RE: Madison Yards at Hill Farms, 4802 Sheboygan Avenue (GDP)

Madison Yards at Hill Farms GDP

A Concept to Add Bike Lanes on Segoe Rd on Segoe Rd

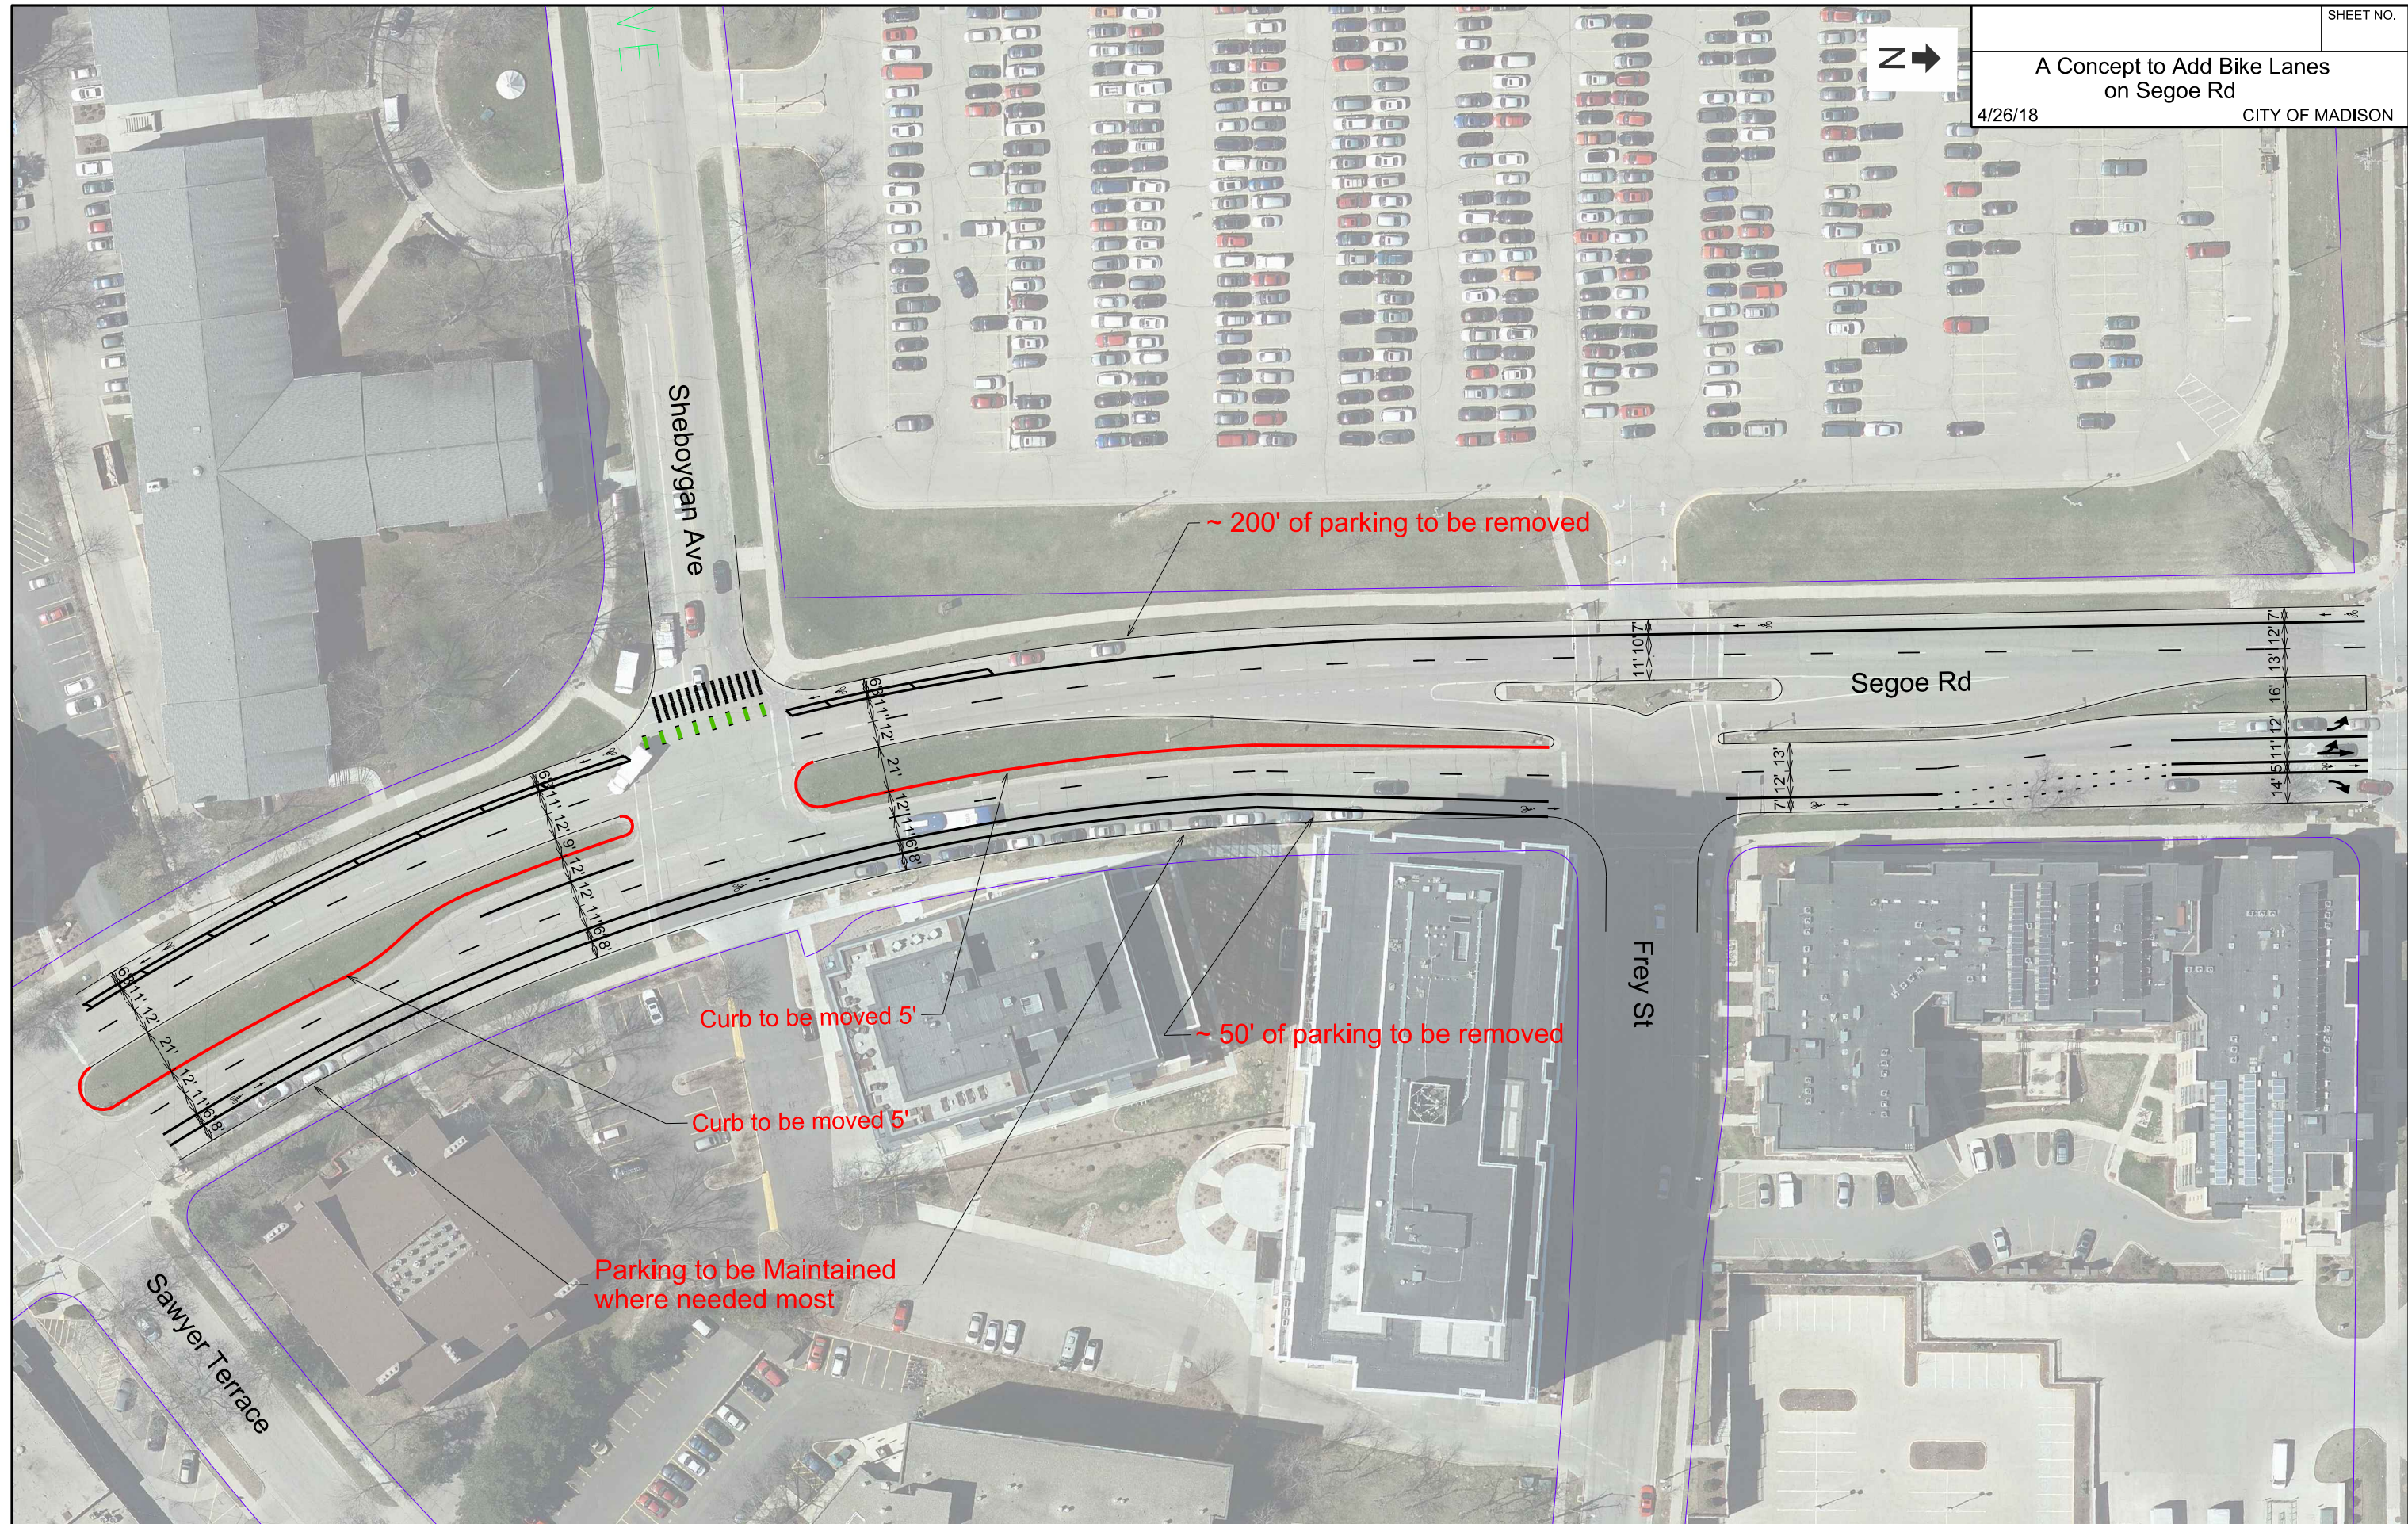
- **The Additional Plan Commission Condition on Bicycle Lanes along Segoe Road**
At the Plan Commission meeting on April 23, 2018, an additional condition was added by the Plan Commission. The condition requires the applicant to work with Traffic Engineering staff to ensure that adequate right-of-way is dedicated along Segoe Road to incorporate bicycle lanes. Following the Plan Commission meeting, Traffic Engineering has worked with Planning, Economic Development, Engineering, Parking Utility, Metro Transit and the applicant, and developed the attached concept to balance the needs for bicycle lanes, bus operation, parking and development. We continue to request right-of-way to widen the sidewalk along Segoe Road and for potential bus pullout bays, but not additional right-of-way for bicycle lanes. The attached concept demonstrates that it is feasible to add bicycle lanes on both sides of Segoe Road within existing right-of-way when parking from the west side of the road is removed and when the eastern curb of the median is reconstructed.
